FOIA Request
FOI 2014-00268

13-QAT-0065

CONTRACT NO. DE-AC27-01RV14136 – U.S. DEPARTMENT OF ENERGY (DOE),
OFFICE OF RIVER PROTECTION (ORP) SURVEILLANCE REPORT S-13-QAT-RPPWTP-
004, SURVEILLANCE OF REVIEW OF BECHTEL NATIONAL, INC.'S (BNI) INTERIM
SURVEILLANCE IN RESPONSE TO OFFICE OF INSPECTOR GENERAL (OIG) REPORT
DOE/IG-0863, RECOMMENDATION NUMBER 2

Surveillance Report S-13-QAT-RPPWTP-004

Electrical panel and Local Operating Panel in C3 LAW Bogie Maintenance Room

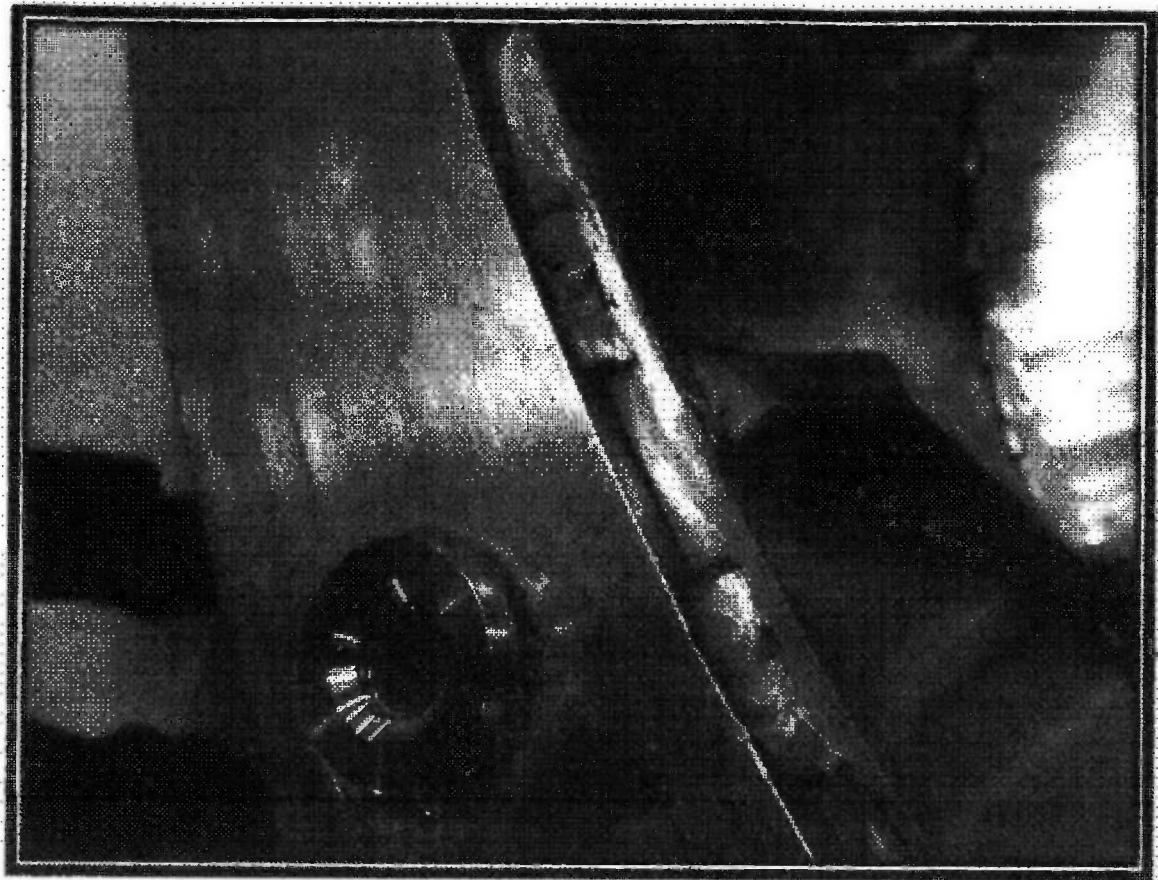
- Electrical panels and local operating stations are unnecessarily located inside a C3 (Contamination Area). Locating operating stations and electrical panels inside C3 areas increases worker dose during routine and maintenance activities, increases generation of radioactive waste (e.g., coveralls, swipes, and decontamination supplies, and results in costly maintenance due to use of personal protective equipment, use of contamination control supplies, and added personnel (Operators and Radiological Control Technicians [RCT])).
